MEETING NOTICE

A meeting of the
Bayside Local Planning Panel
will be held in the Committee Room, Botany Town Hall
Corner of Edward Street and Botany Road, Botany
on **Tuesday 27 November 2018 at 6:00 pm.**

Bayside Local Planning Panel

Supplementary Planning Assessment Report

Figure 1 Comparison of the previous (left) and the current (right) shadow diagrams – 9am (Resolut, 2018)

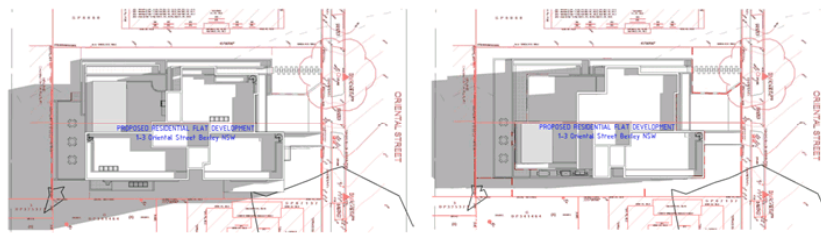
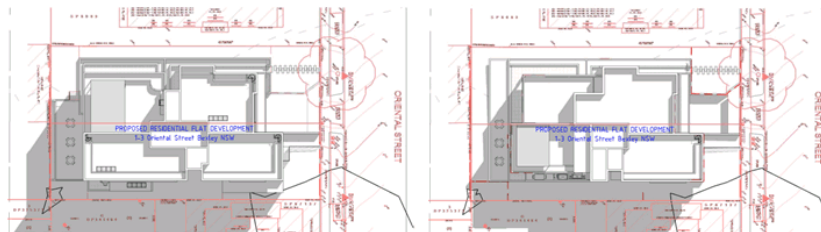
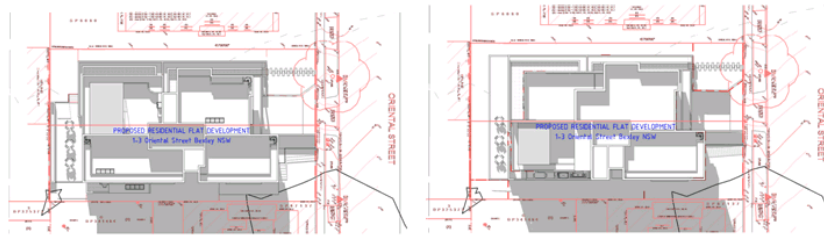
The amended shadow diagrams depict a significant reduction in the length of the shadows cast on to neighbouring buildings. The deletion of the previous Unit 13 will especially result in marked improvements to solar access to the surrounding properties.

Figure 6 Extract from survey showing location of balconies that are the subject of the submission (S.J. Surveying Services Pty Ltd, 2015)

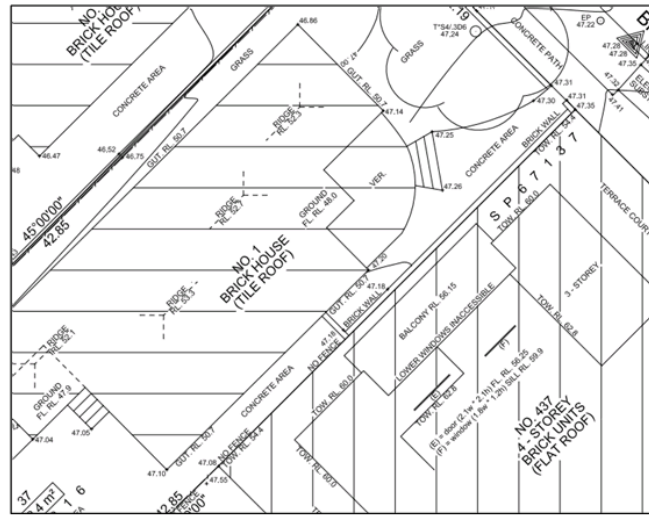
The outer edge of these balconies measures to be approximately 0.4m from the boundary shared with the subject site. As discussed within the previous report, there is a masonry boundary wall located within the front section of the shared boundary.

The level of the higher balconies is RL56.15 as shown on the survey. The survey does not show the levels of the floor below but it would be estimated to be approximately and approximately RL 53.2. These levels would approximately correspond with the floor levels of Level 2 and Level 3 within the proposed development.

Figure 7 Comparison of the previous (left) and the current (right) shadow diagrams – 12pm (Resolut, 2018)

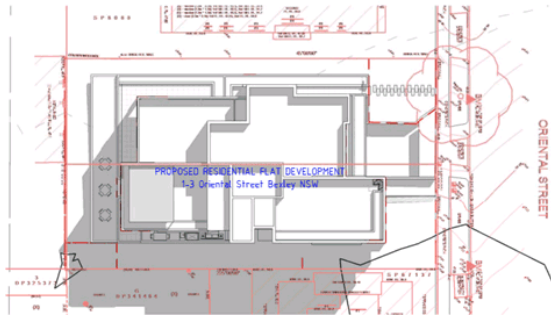
Elevation shadow diagrams have not been provided with this application. However, the amended 12pm shadow diagram (shown again below) indicates that the design has deliberately sought to avoid overshadowing to these balconies.

It is likely that the proposal will cast shadows on to these balconies at certain times within midwinter. However, preservation of solar access to these balconies is extremely difficult, given they are located only 0.4m from the common boundary and to preserve solar access to these balconies would unduly sterilise the development potential of the subject site. The proposal is able to be supported in this regard.

Figure 3 Neighbouring building at 437 Forest Road, viewed from Oriental Street (Steven Layman Consulting, 2016)

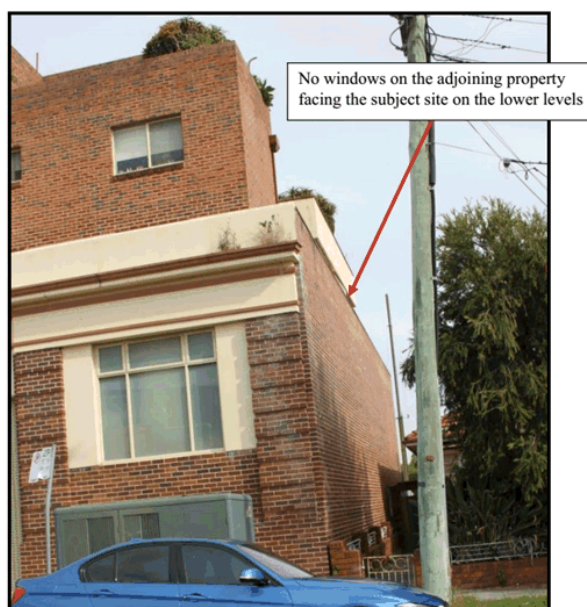
It is agreed that a suitable response to the minimal setback to the blank wall shown above, within 437 Oriental Street, is to provide lesser setbacks than that required by the ADG. However, this wall lies adjacent to the front dwellings of the proposed development, but not adjacent to the rear dwellings. The proposed rear dwellings lay adjacent to the properties from 443-449 Forest Road. Furthermore, the wall is 7m tall, well short of the proposed height of the development, which is in excess of 14m.

Figure 4 12pm midwinter shadow diagrams (Resolut, 2017)

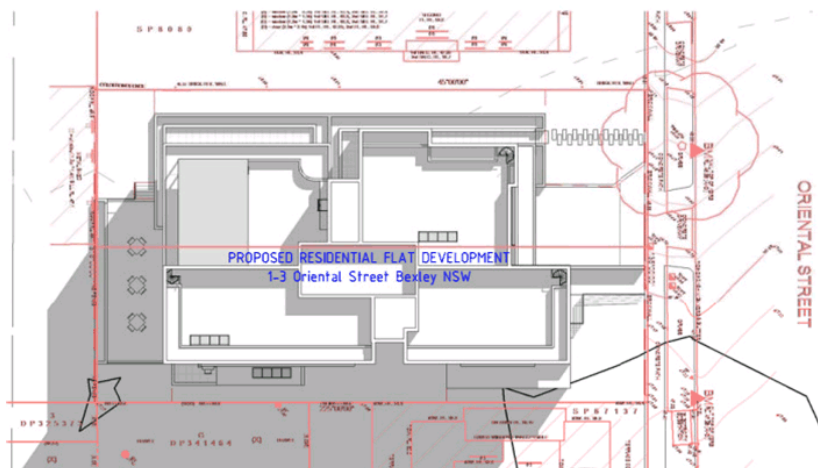
With respect to overshadowing to surrounding properties, Figure 4 provides an example of the information that was provided to demonstrate the impacts to neighbouring properties. The shadow diagram within Figure 4 depicts the overshadowing to neighbouring properties. However, very limited information is provided on the neighbouring properties. No elevation shadow diagrams have been provided to demonstrate the impacts to balconies, etc, and insufficient information is provided to enable any proper understanding of the impacts to ground level overshadowing, as the entirety of the shadows are not shown.

Figure 5 12pm Level 1 midwinter sun path shadow diagrams (Resolut, 2017)

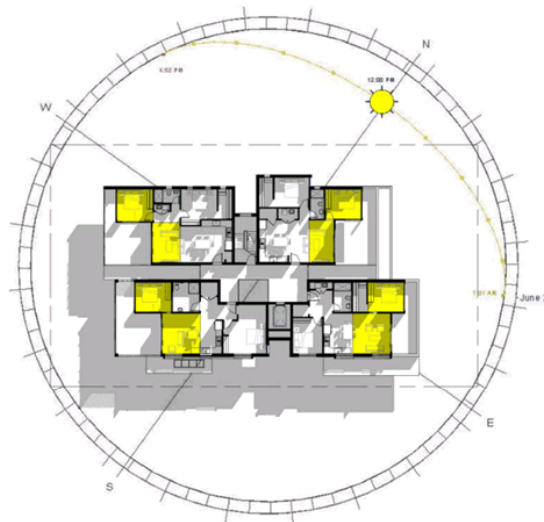
With respect to solar access to the subject property, Figure 5 provides an example of the information that was provided to demonstrate the solar access received by dwellings within the development. The submitted Statement of Environmental Effects indicates that 100% of units receive compliant solar access. However, this is not possible, given:

Figure 6 12pm Level 3 midwinter sun path shadow diagrams (Resolut, 2017)

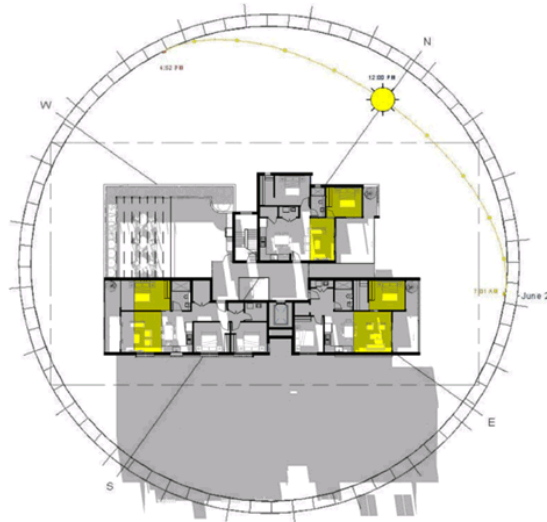
Finally, with respect to overshadowing to the proposed communal open space areas, Figure 6 provides an example of the information that was provided to demonstrate compliance. The direction of the shadow diagrams would be expected to be cast in a southerly direction, identical to those shown within Figure 5, however, the shadow diagrams depict shadows being cast towards the southeast. It is not possible to determine the level of solar access that is received to the communal open space. Excellent solar access should be provided to the Level 3 communal open space, as the ground floor communal open space, provided within a narrow and non-compliant rear setback area, would receive very little midwinter solar access.
